March 2, 2018

Subject: Civil Site Development Plans for Mark Black Wedding Venue

This letter constitutes an update to my letter to you on February 17, 2108 on the failure of the Mark Black Wedding Venue Civil Site Development Plans to meet the City of Dripping Springs ordinance standards and protect the uniquely sensitive and pristine land, creeks, springs, and environment within its jurisdiction. In preparing the opinions herein, I have reviewed the following supplemental documents:

Figure 2-1 Rainwater Collection Credit

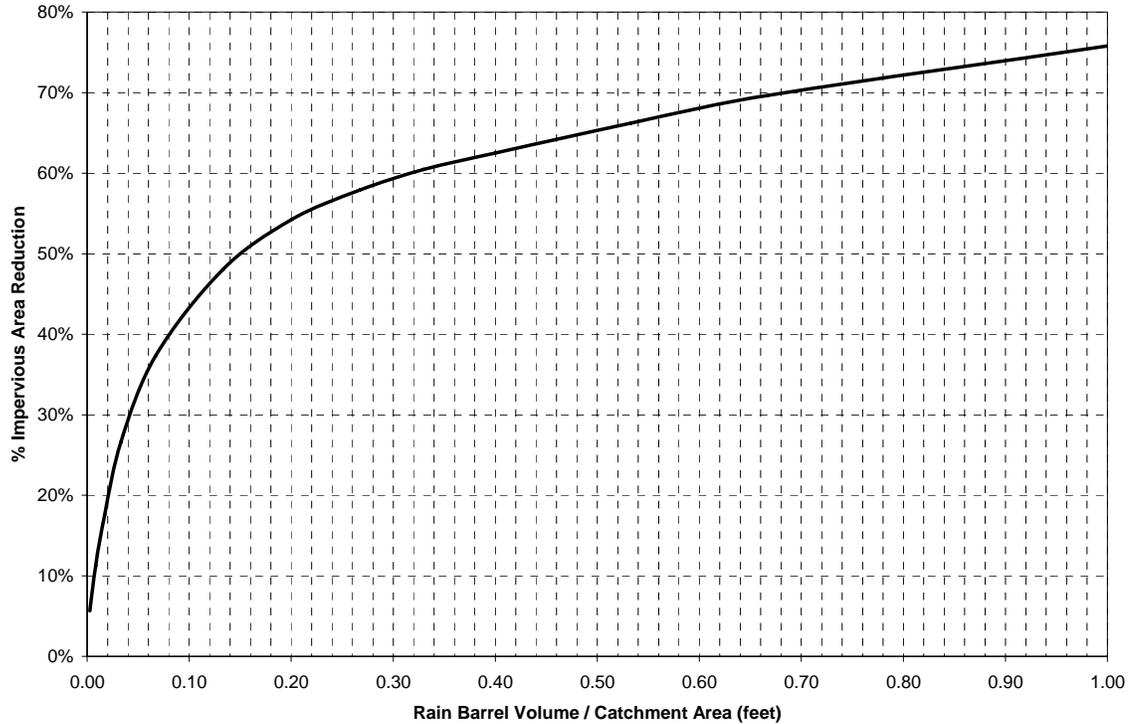
3. TSS, TP, and O&G removal calculations on Sheet 38 of the Civil Site Plans include removal efficiencies for rainwater harvesting. The applicant has not, however, specified the size of rainwater cisterns and therefore cannot take credit for any pollution removal.
